Subject: Limerick Generating Station, Units 1 and 2
Request for Information from the Power
Systems Branch

Reference: Meeting with the Power System Branch Reviewer,
E. Tomlinson, and Philadelphia Electric
Company on March 9-10, 1983

The attached documents are draft question response changes and draft text changes to the FSAR resulting from the discussion with Mr. E. Tomlinson at the referenced meeting. Please note that complete changes to the response to question 430.75 are not provided at this time and will be made available at the end of April, 1983.

FIGURE 9.5-10

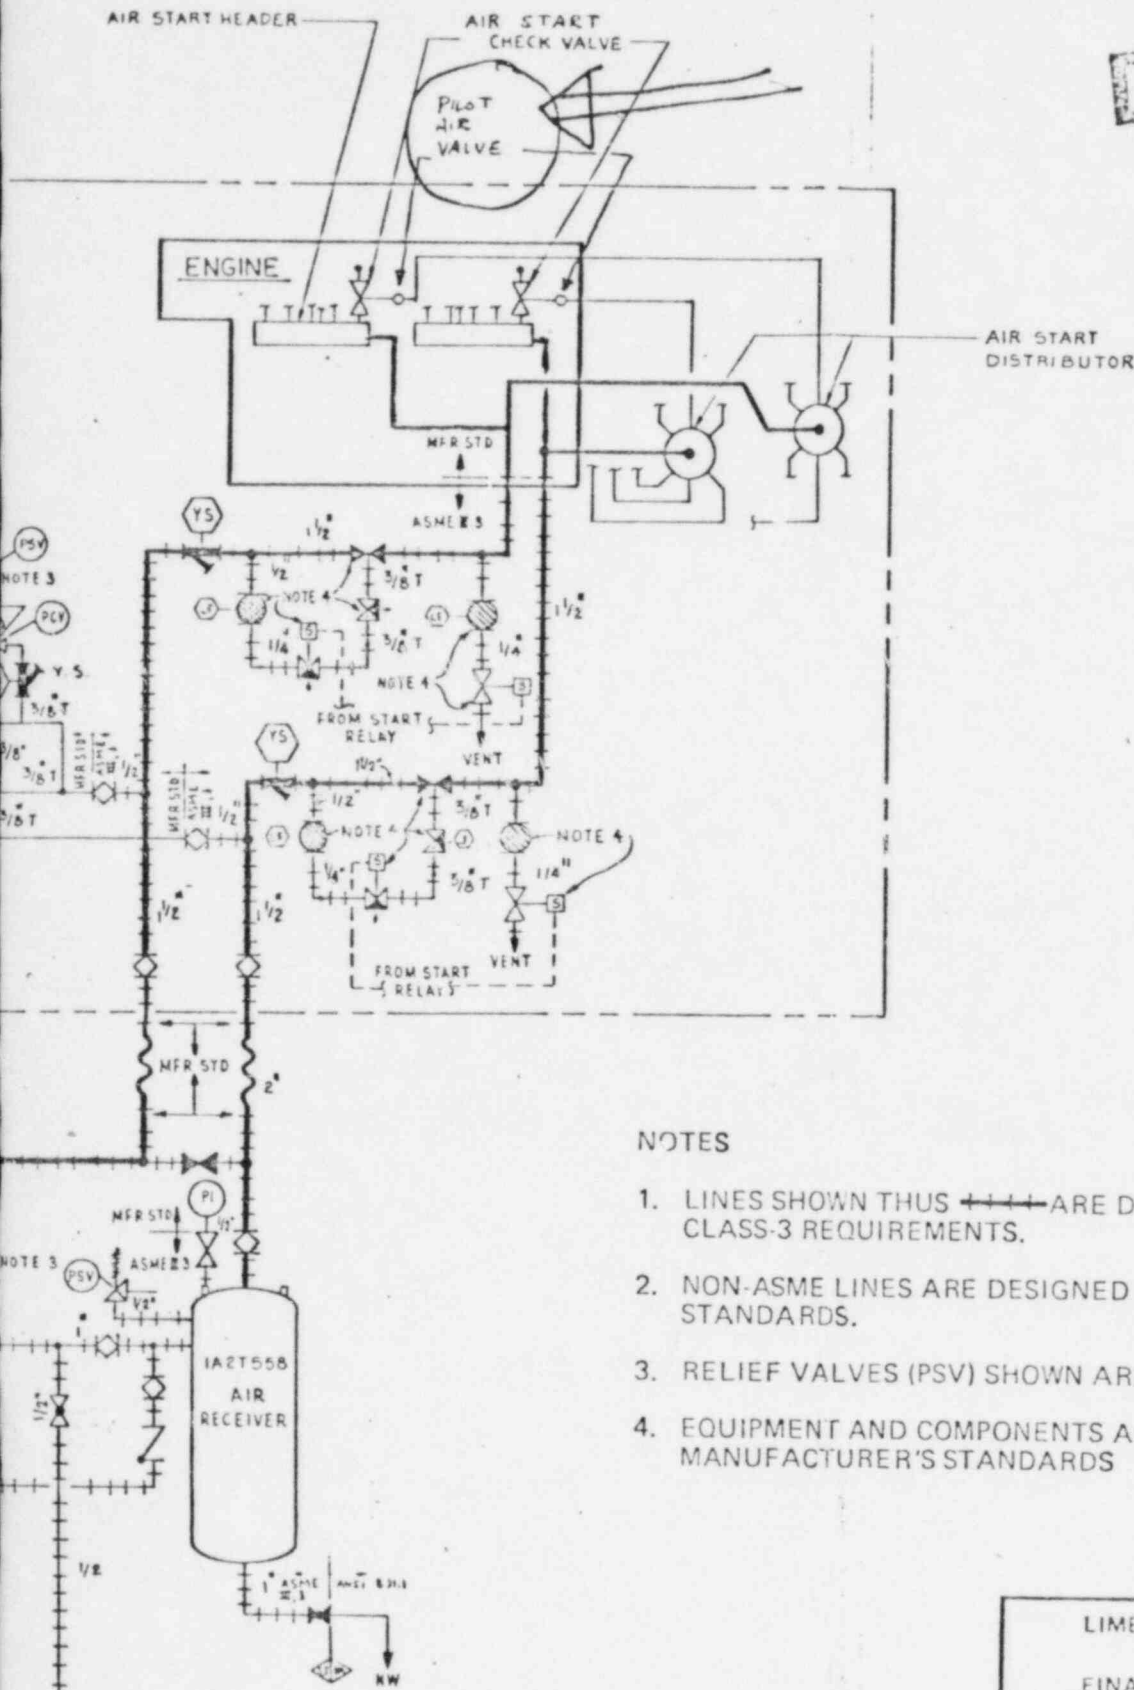
QUESTION 430.101 (Section 9.5.6)

Sections 9.5.6.2 and 9.5.6.3 and Figure 9.5-10 have been changed to provide the requested information. Tests have been performed to demonstrate the air receiver capacity in lieu of calculations. The test results are available for NRC review.

FIGURE 1.2-36

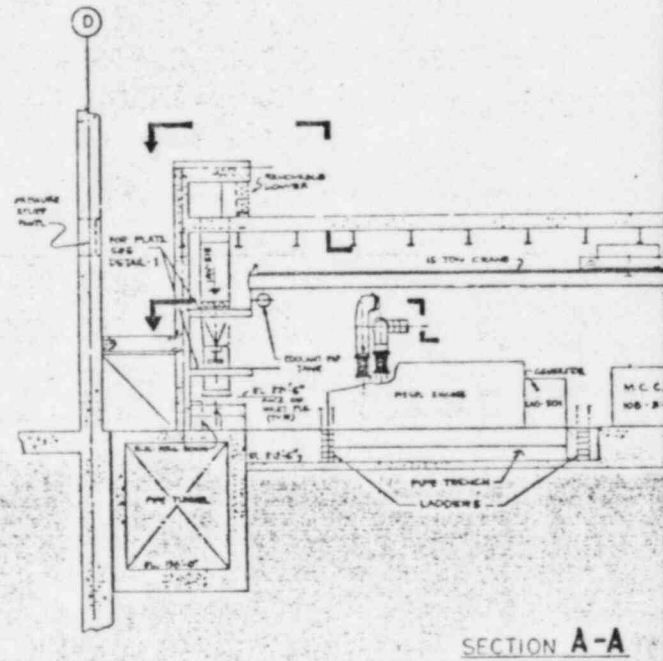
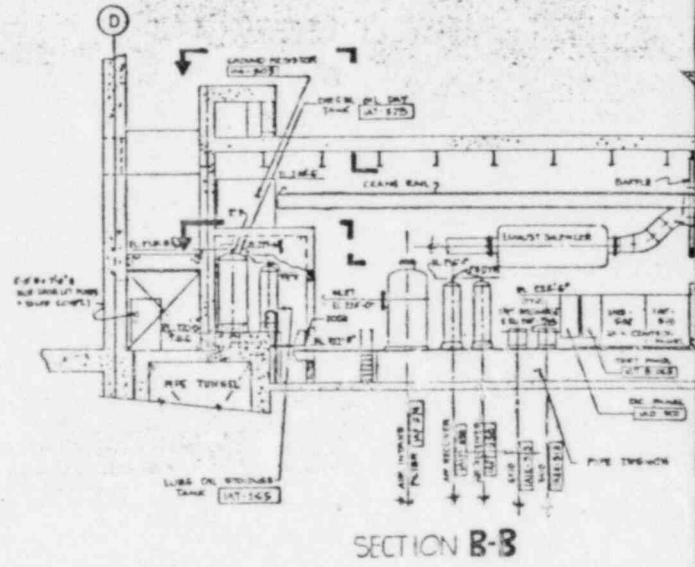
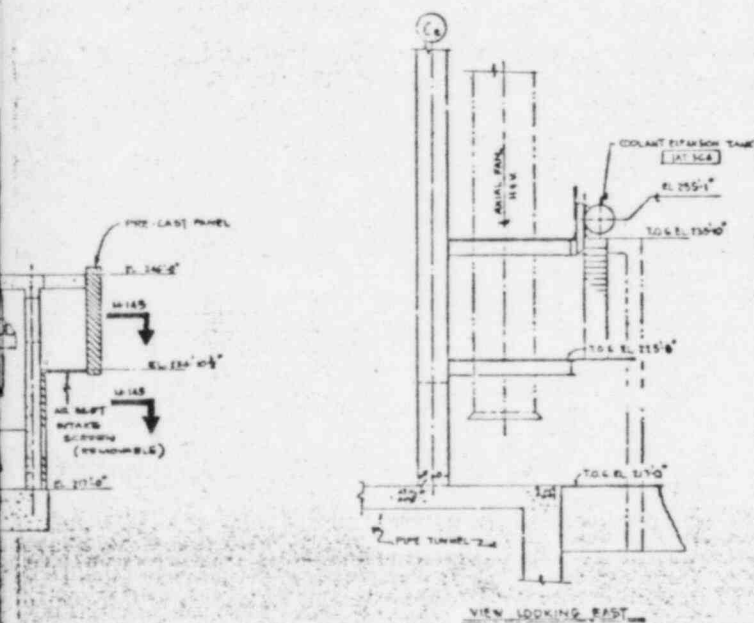
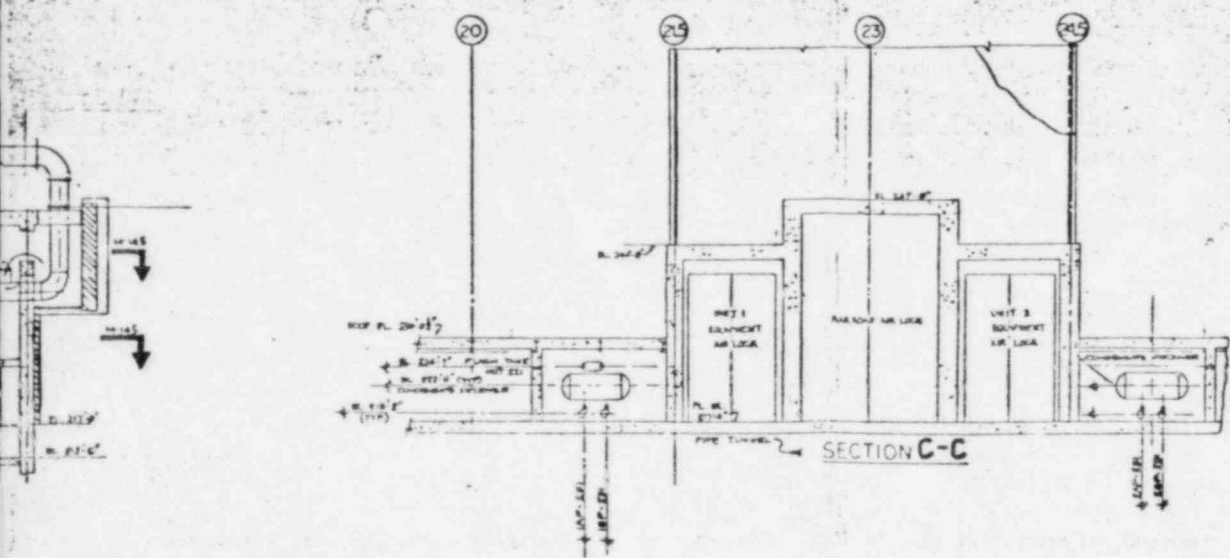
The diesel engine exhaust piping shown on Figure 1.2-36 is not in concurrence with the description in Section 9.5.8. Figure 1.2-36 shows a 45 degree fitting at the end exhaust piping, while the text discusses an elbow at the same location. Revise your FSAR to resolve this inconsistency. Also, expand your FSAR discussion to show how the presence of water, dust, ice, or snow in the exhaust system would be detected and what provisions will be made for removal of same.

Section 9.5.8.3 and Figure 1.2-36 have been changed to provide the requested information.

Sections 9.5.8.2 and 9.5.8.3¹ have been changed to provide the requested information.

and Figures 1.2-36 and 9.5-12

FIGURE 9.5-12 REV. 17, 02/83

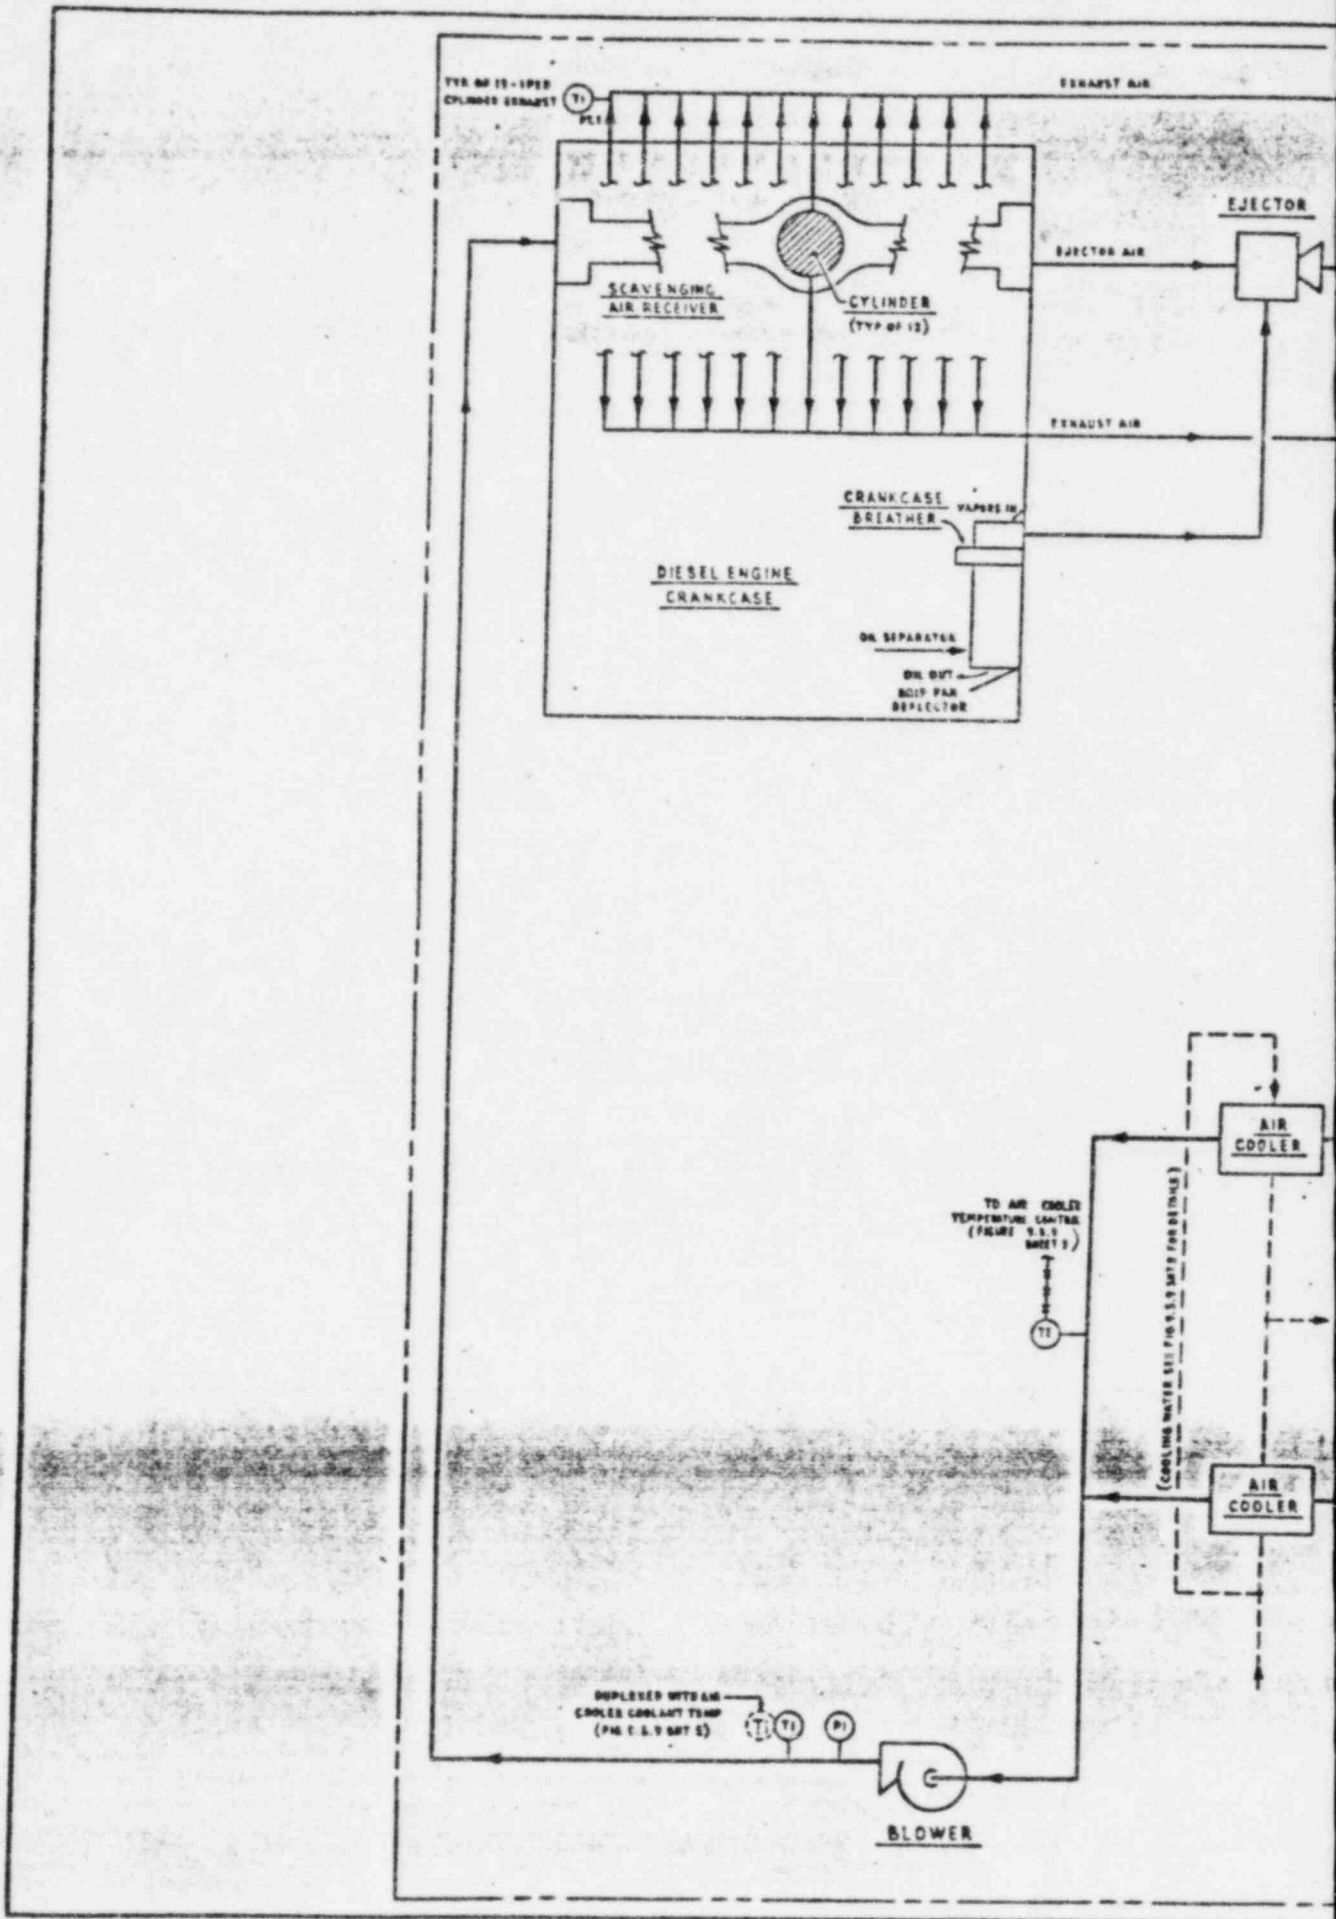
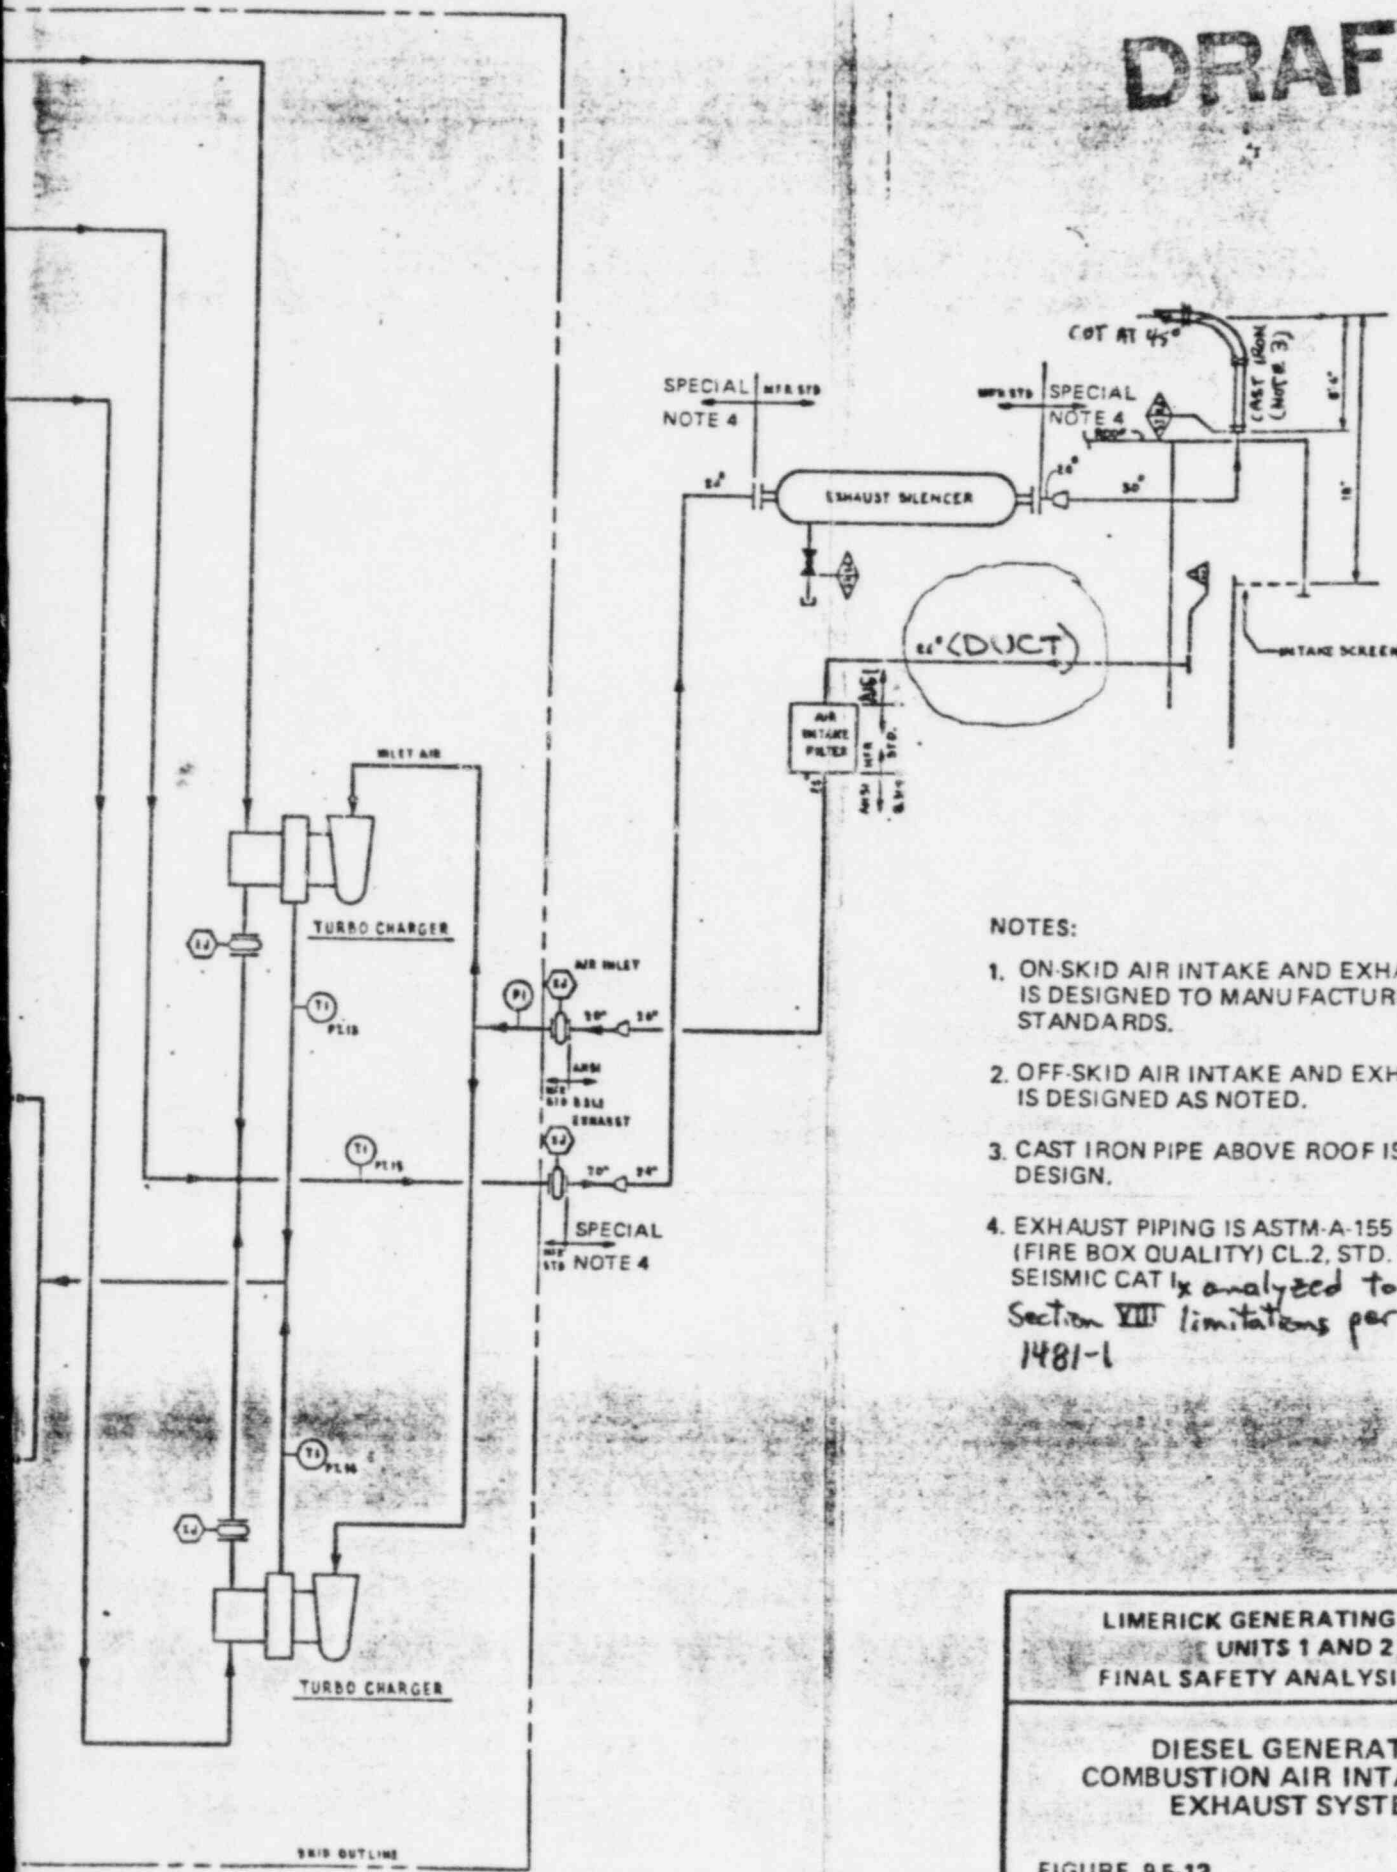
Provide an enlarged P&ID for the emergency diesel engine combustion air intake & exhaust system. On the drawing, clearly indicate all piping, all instrumentation and controls, all components, engine interfaces, building penetrations, quality group classifications for all piping and components, and any locations where quality group classifications change.

Figure 9.5-12 and Table 3.2-1 have been changed to provide the requested information.
